802.3ch coupling attenuation graph fix

# 802.3ch channel performance

## Channel coupling attenuation proposal

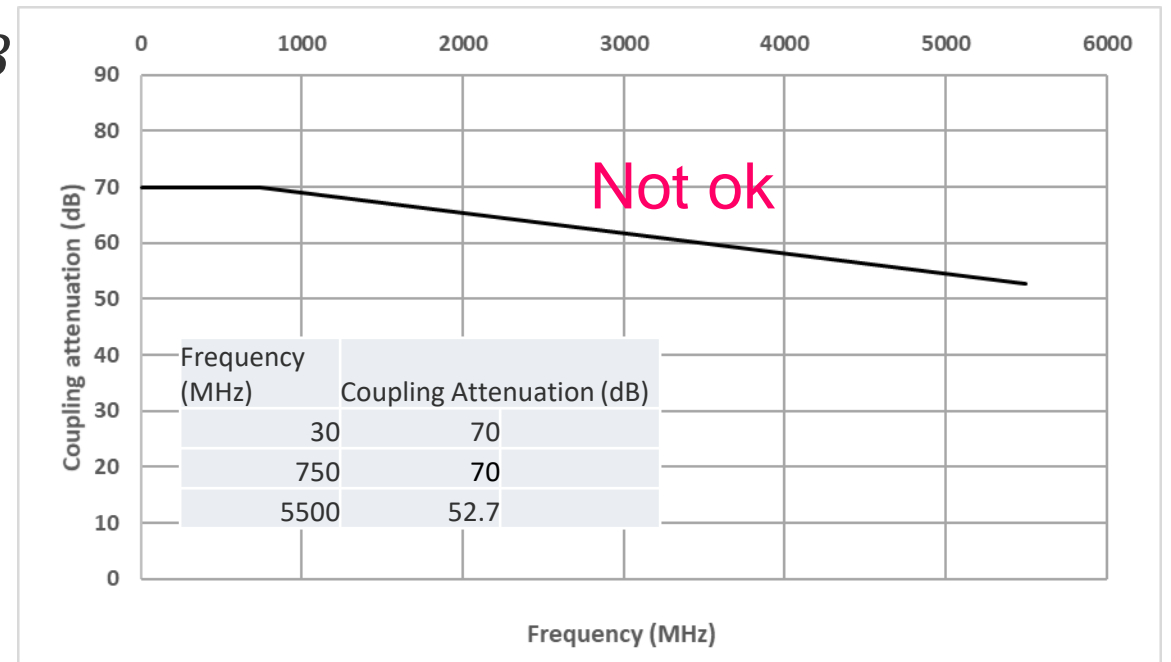
- Graph in mueller\_3ch\_channel\_02a\_0518.pdf doesn't correctly represent the formula voted on.
- Graph must be linear between 750 MHz and 5500 MHz when x-axis is in log scale, not linear scale.
- Formula and table are ok

$$\begin{pmatrix} 70 & 30 \leq f < 750 \\ 50 - 20\log(f/7500) & 750 \leq f \leq 5500 \end{pmatrix} dB$$

- Here are the fixed graphs either in log or in linear scale on x-axis
